OFFICIAL AMENDMENT

Application 09/925,059

Reply to Office Action of May 25, 2005

FIG. 2

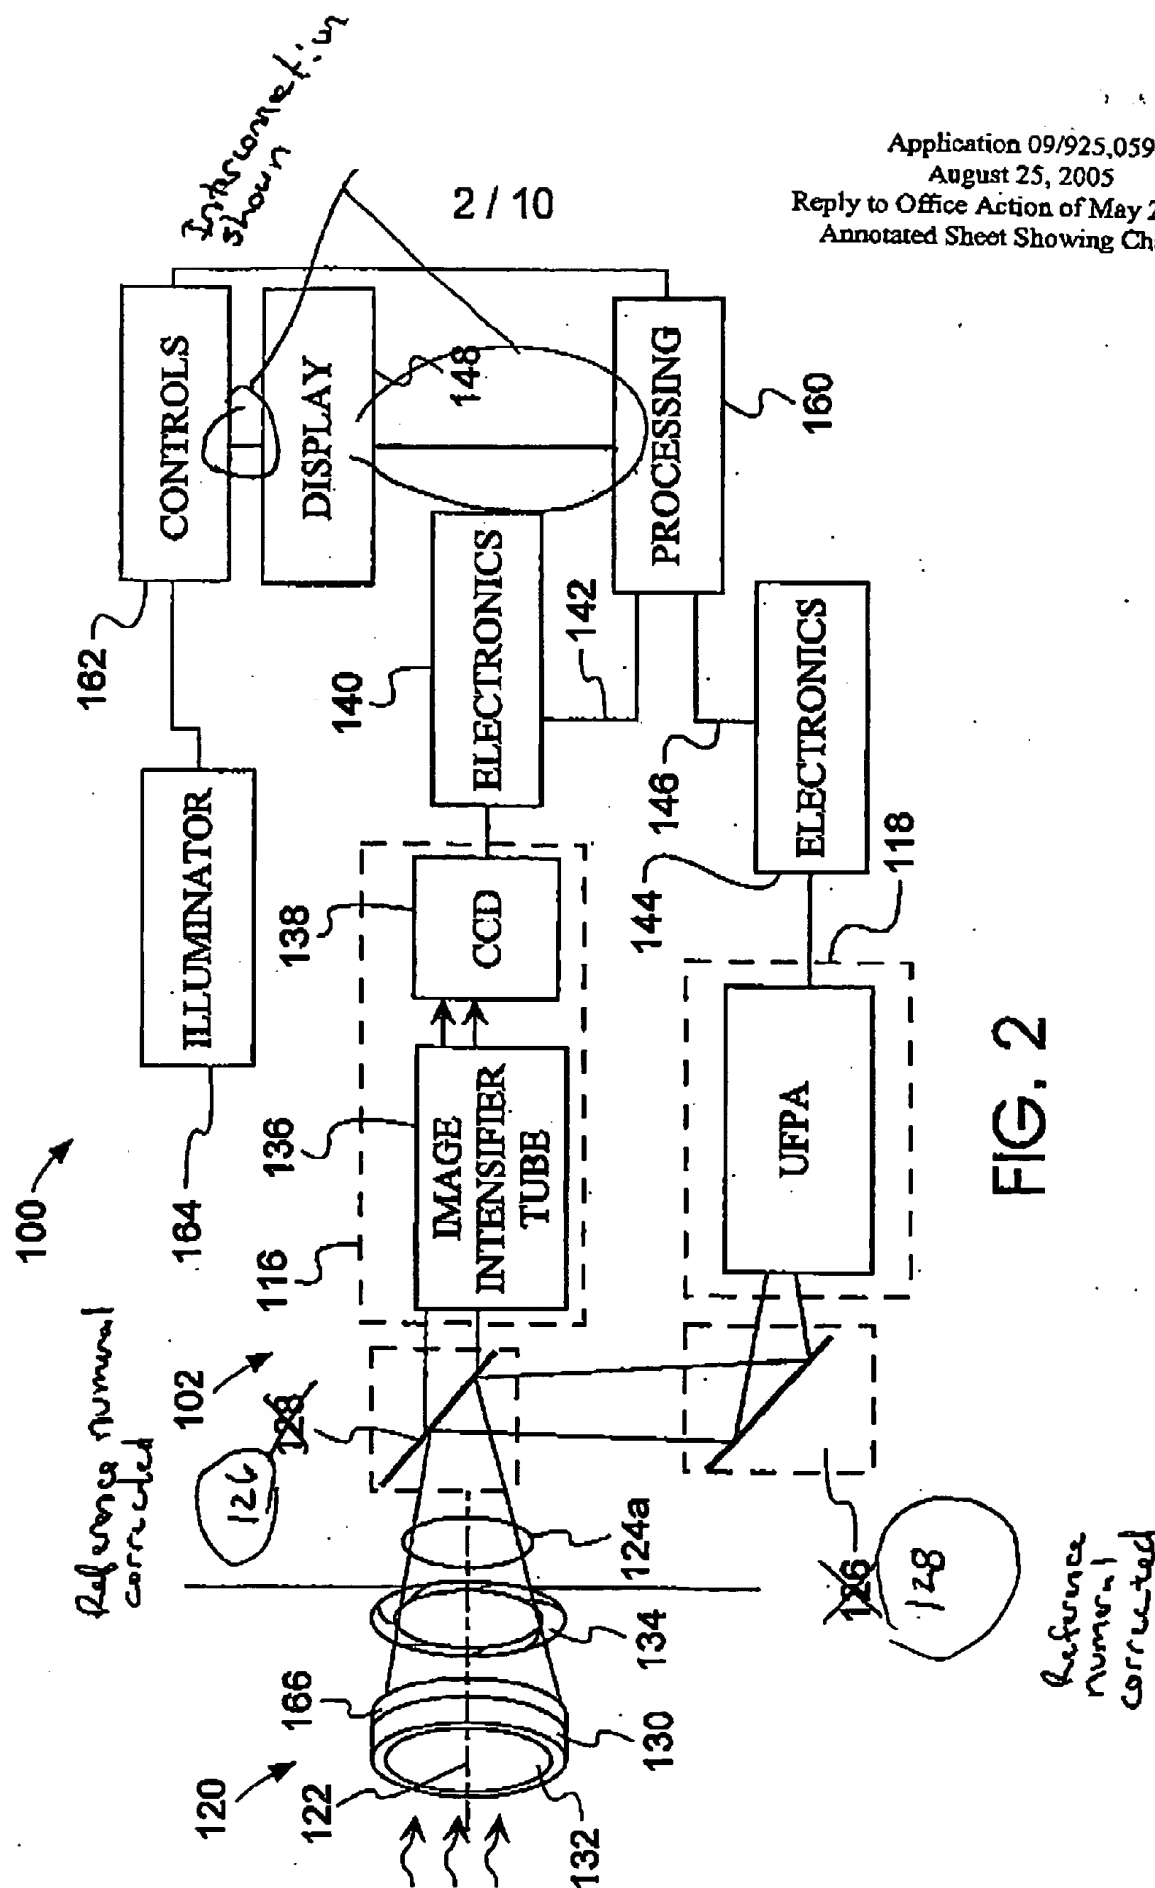
The first attached sheet of drawings includes changes to Fig. 2. This sheet, which includes Fig. 2, replaces the original sheet including Fig. 2. In Figure 2, a line connecting the display 148 to the controls and processing was omitted and has been added. The correction to the drawing is fully supported by the specification and the applicant believes that no new matter has been added.

FIG. 3A

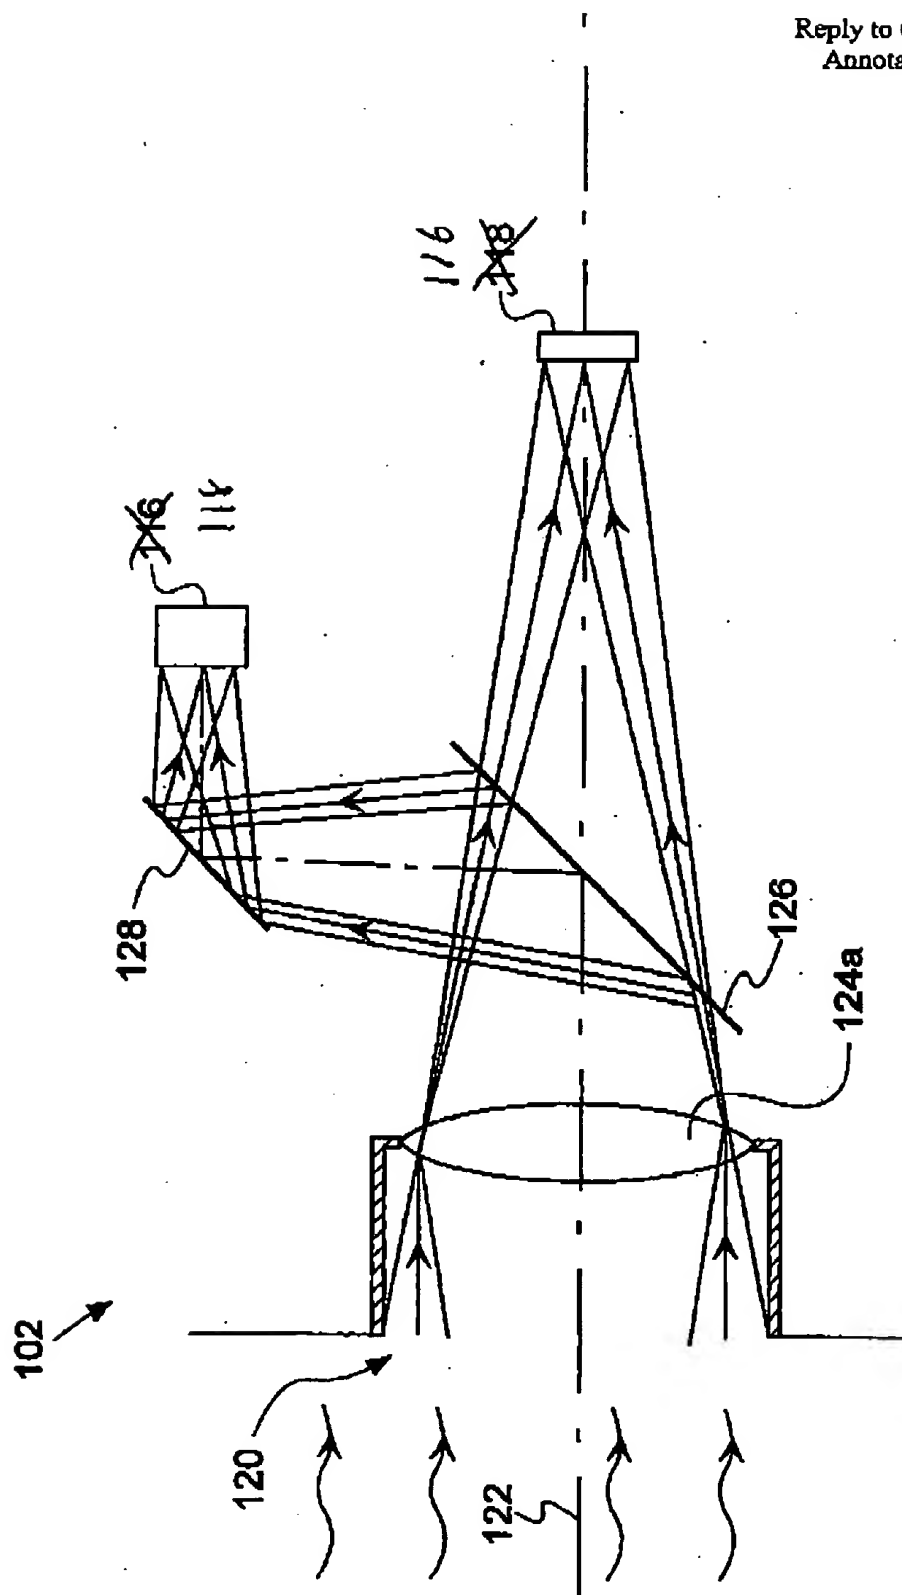
The second attached sheet of drawings includes changes to Fig. 3A. This sheet, which includes Fig. 3A, replaces the original sheet including Fig. 3A. In Figure 3A, reference numbers 116 and 118 were inadvertently transposed. The correction to the drawing is fully supported by the specification and the applicant believes that no new matter has been added.
